ERRATA

A COMPLIANT WALL, SUPERSONIC WIND TUNNEL E. H. Dowell

The author wishes to make the following corrections to his technical note published in the October 1978 issue of the *Aeronautical Journal*, pages 448-451:

Figure 3. Aeroelastic coefficients required for zero wall interference; divergence aeroelastic coefficient shown for reference.

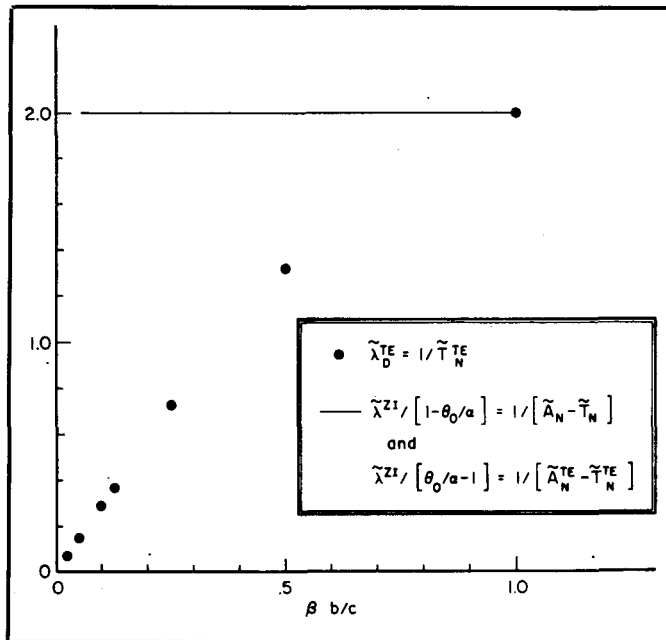
Figure 3 should be replaced by the figure shown below.
